ZAYO'S PRINEVILLE TO RENO PROJECT

CPUC MINOR PROJECT REFINEMENT FORM

Date Requested: 15 Oct 2024 submitted to CPUC on October 21, 2024	Report No.: 5
Date Approved: 10/25/2024	Approval Agency: Caltrans, in addition to CPUC
Property Owner(s): Caltrans (State Route 395 ROW)	Location/Milepost: PM M-29.7 to M-32.5 (S to N)
Land Use/Vegetative Cover: Ruderal (maintained highway shoulder near edge of pavement)	Sensitive Resources: Waterways at culverts to be avoided by boring underneath culverts. Cultural resources will still need to be avoided. (See project webmap.)

SHEET NO.: 54 OF 94

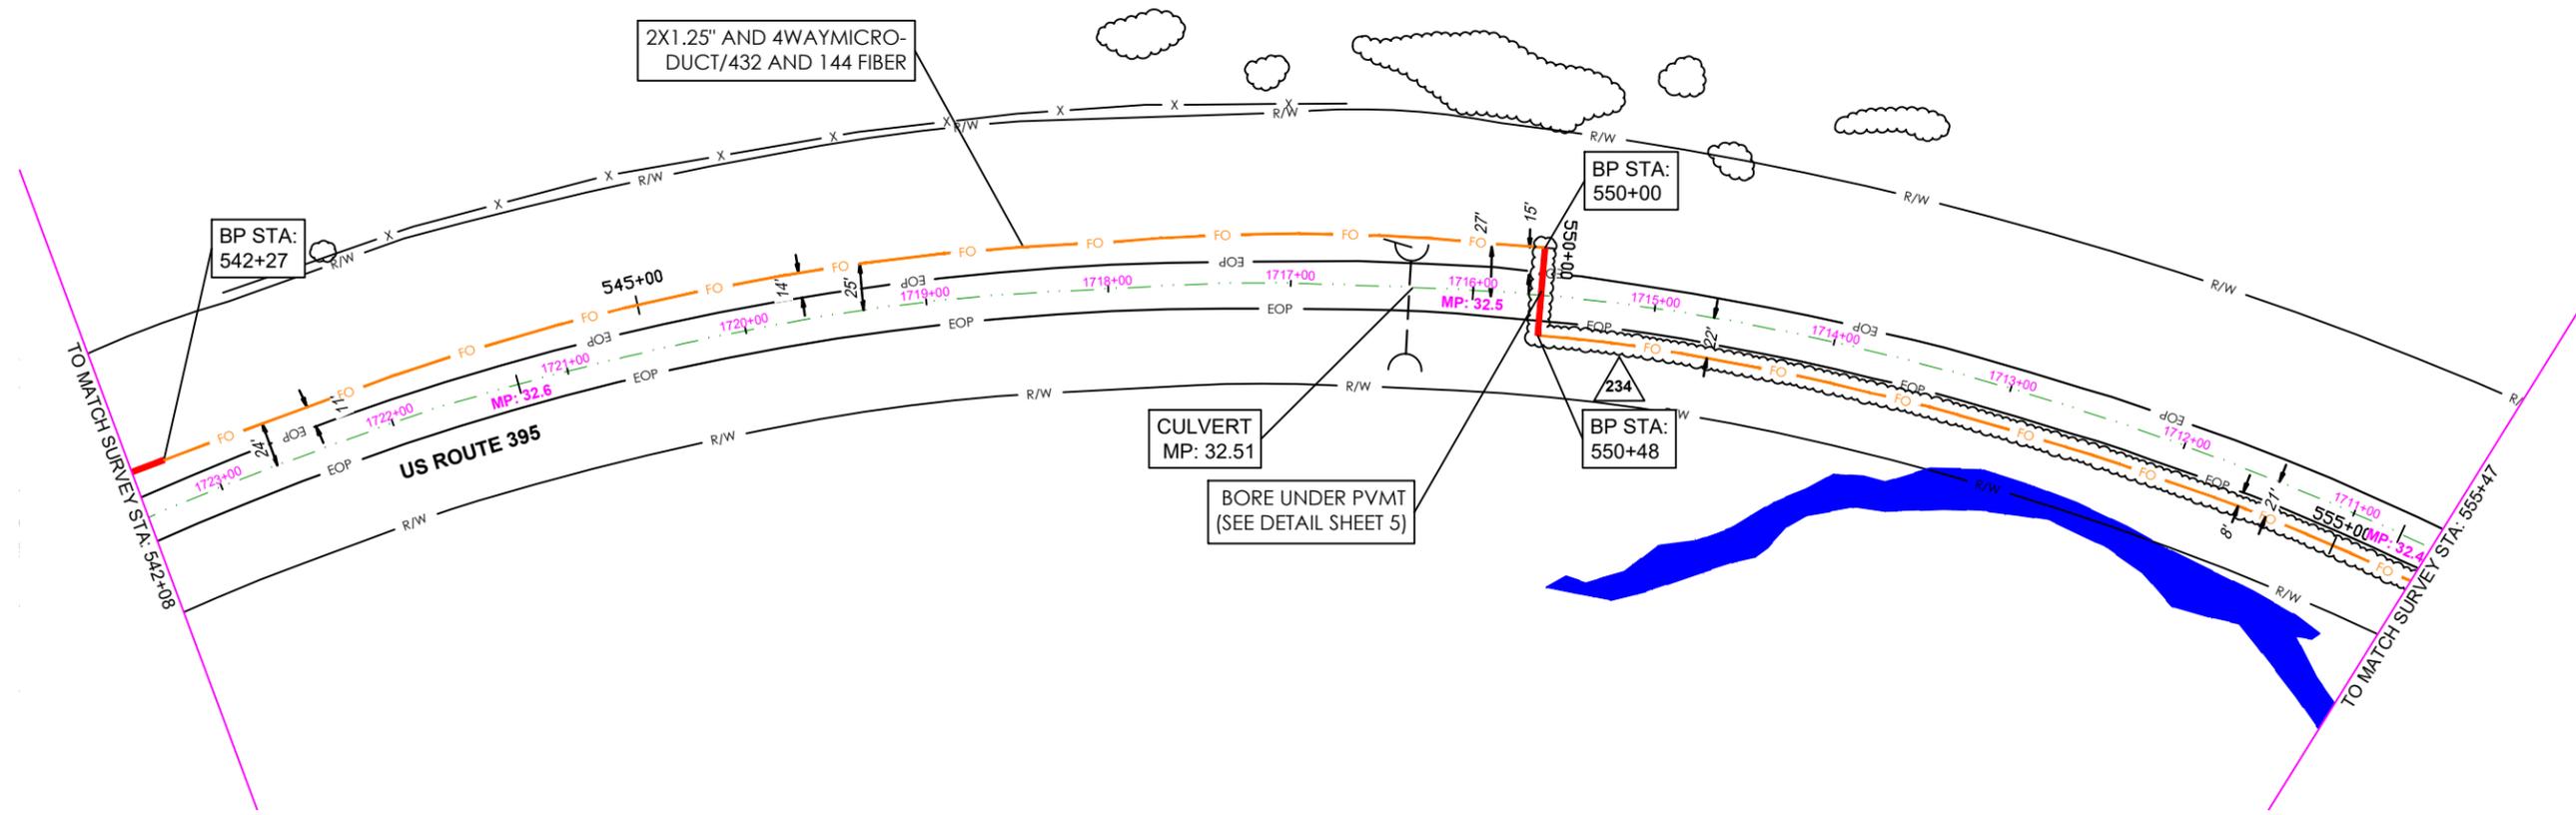
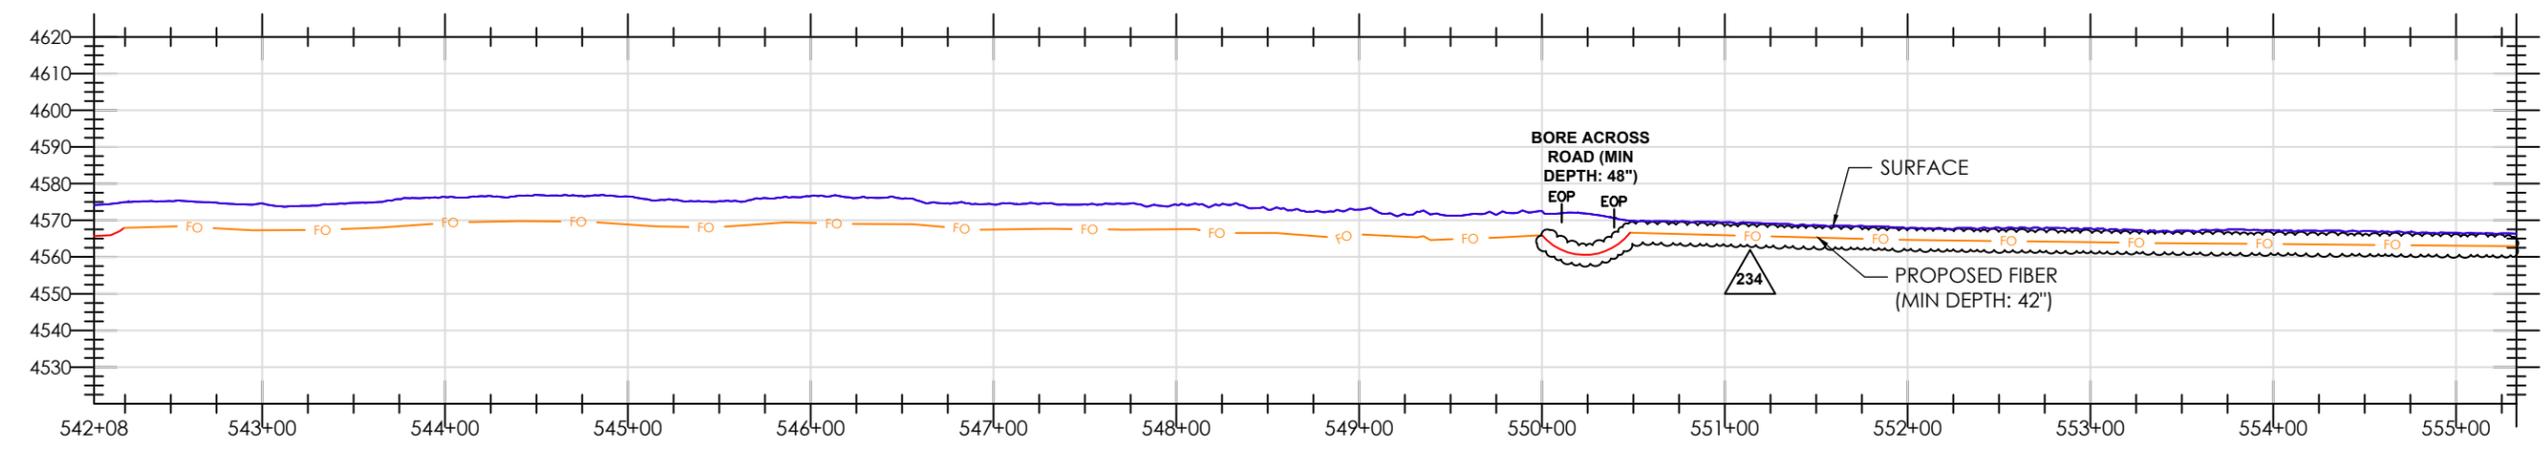
RFI NO. 0234
SHIFT ALIGNMENT TO WEST SIDE
8 FEET FROM EOP
EOP STA 550+00 TO STA 619+90
09/30/2024

SHEET NO.: 55 OF 94

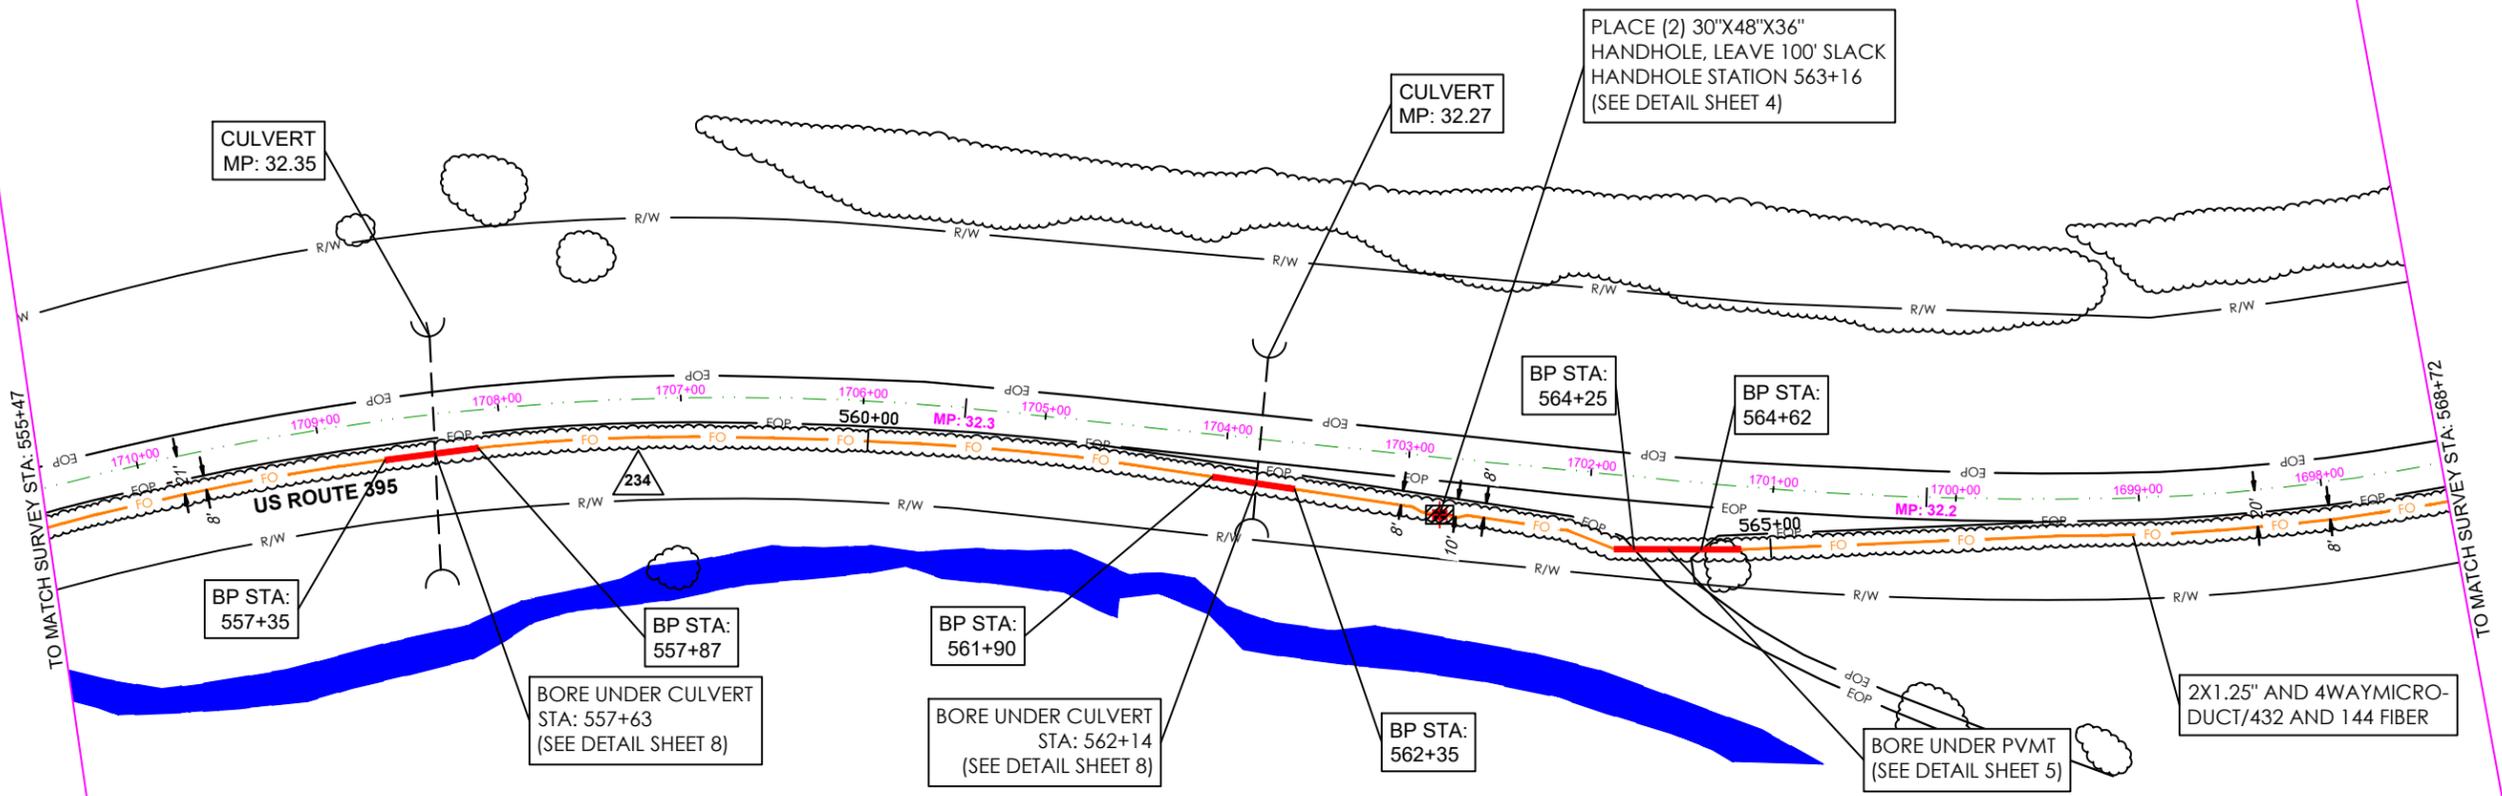
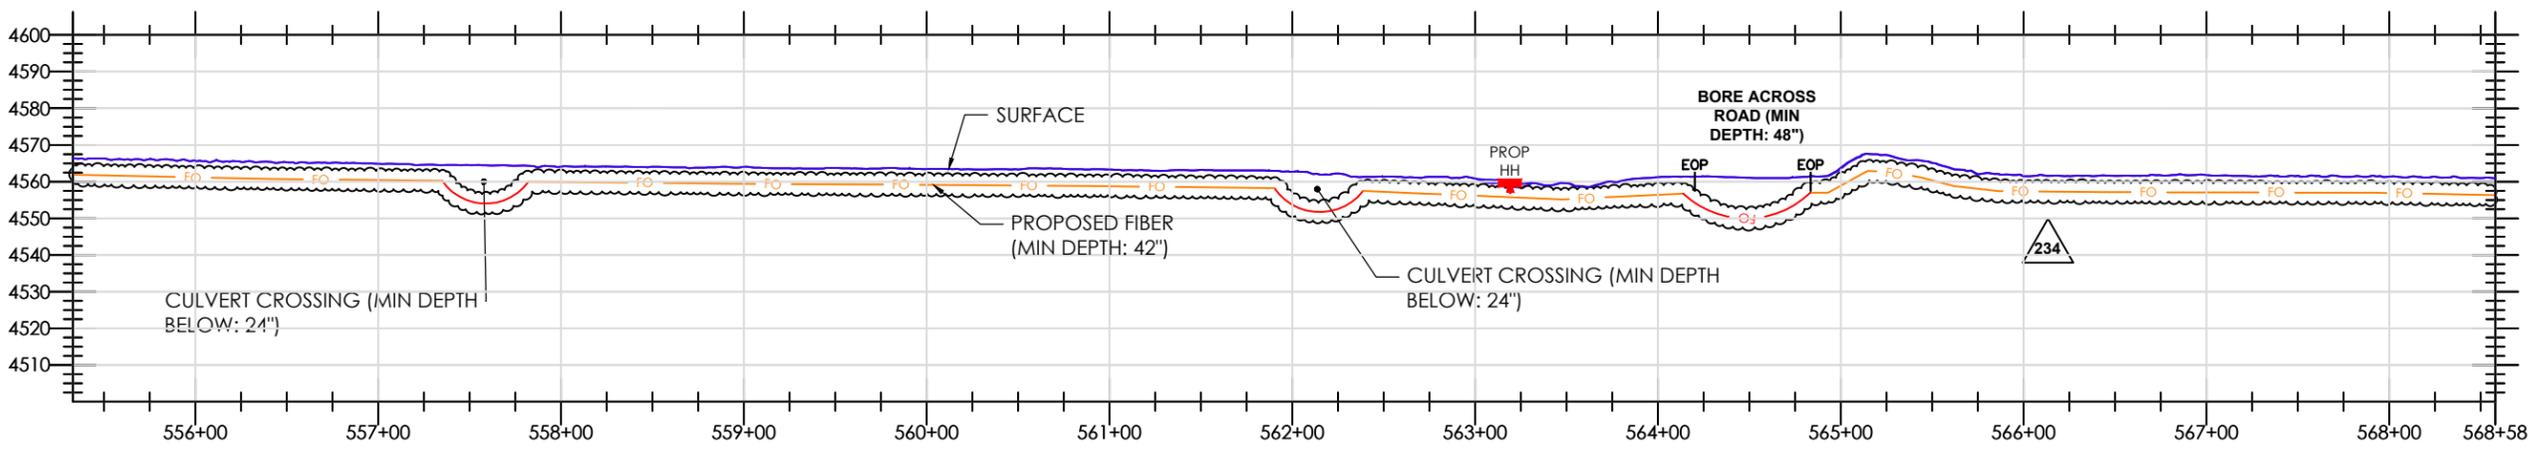
RFI NO. 0234
SHIFT ALIGNMENT TO WEST SIDE
8 FEET FROM EOP
EOP STA 550+00 TO STA 619+90

SHEET NO.: 58 OF 94

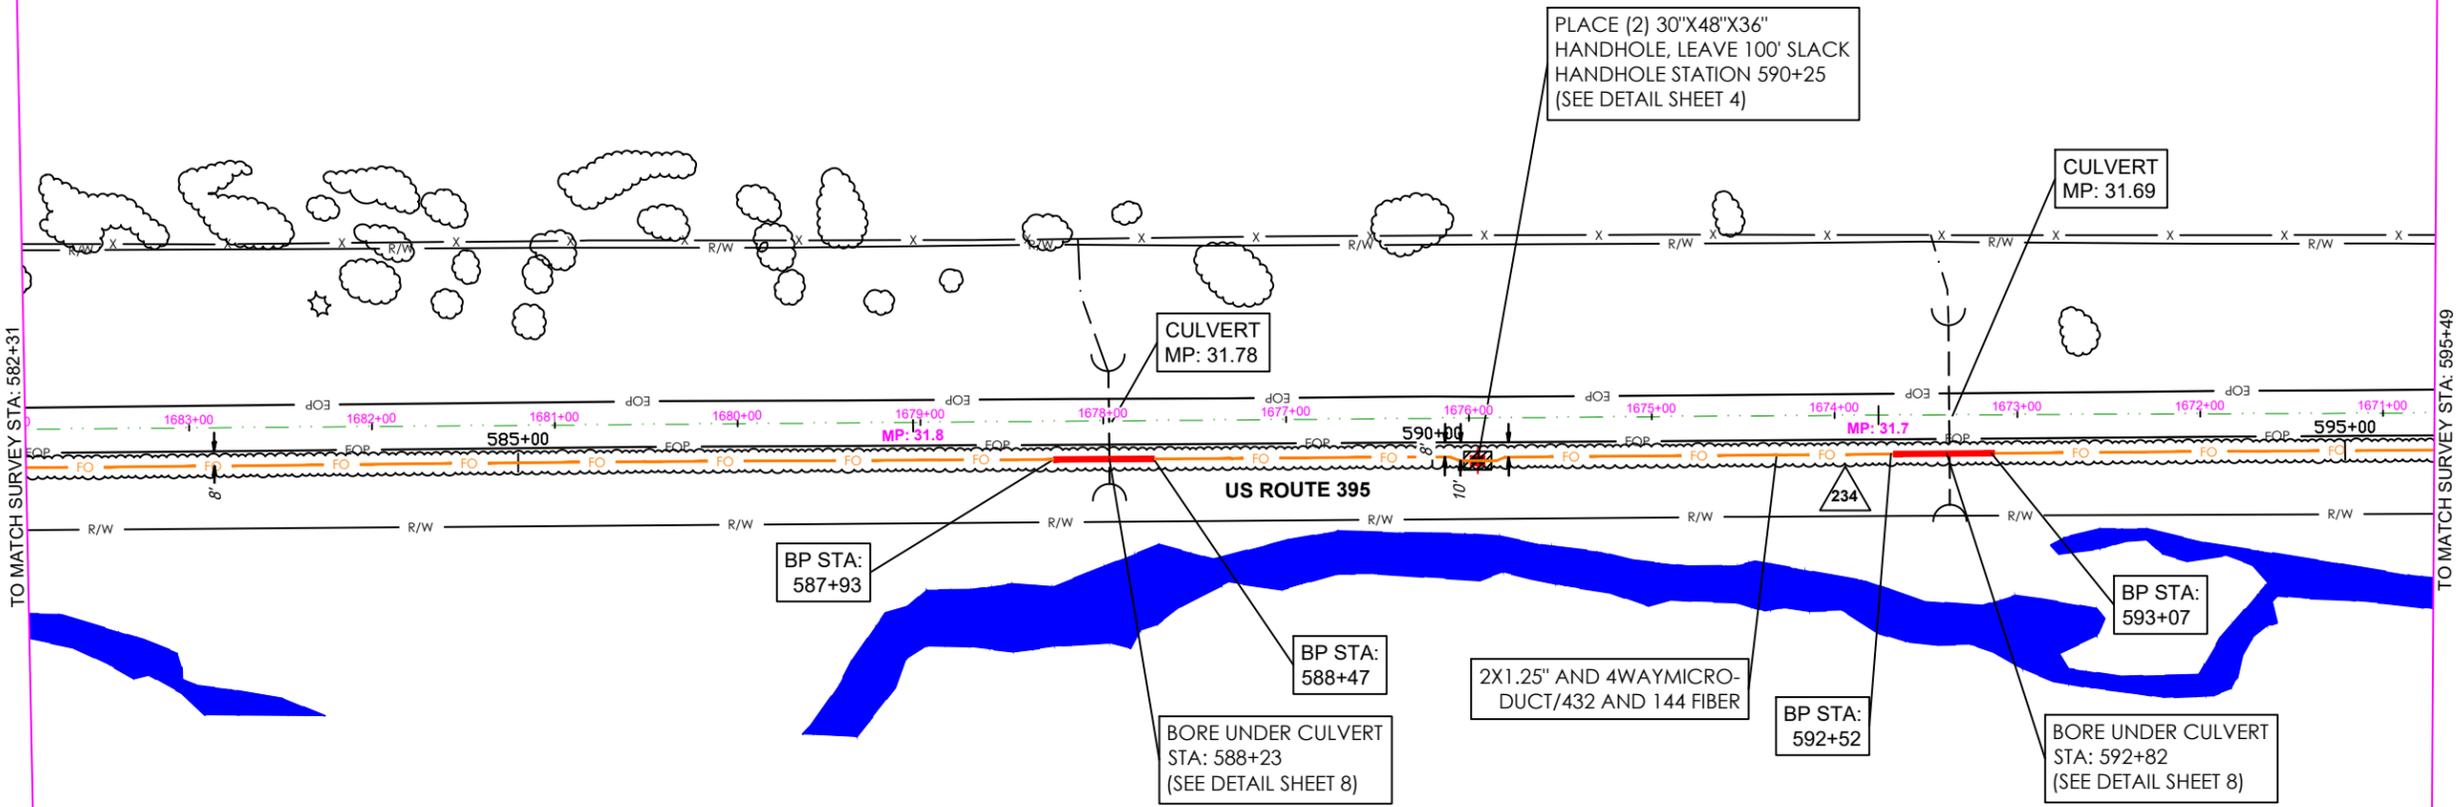
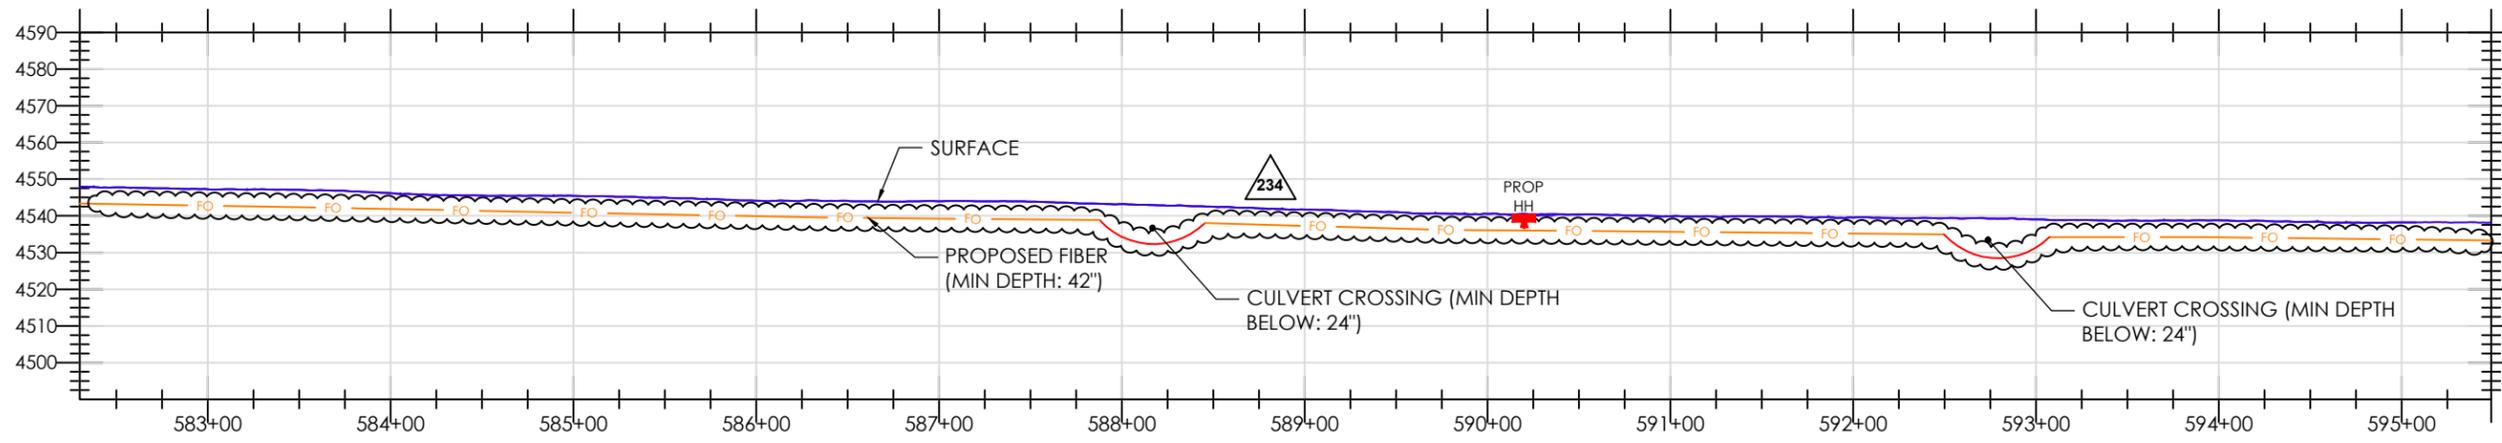
RFI NO. 0234
SHIFT ALIGNMENT TO WEST SIDE 8 FEET FROM EOP
EOP STA 550+00 TO STA 619+90
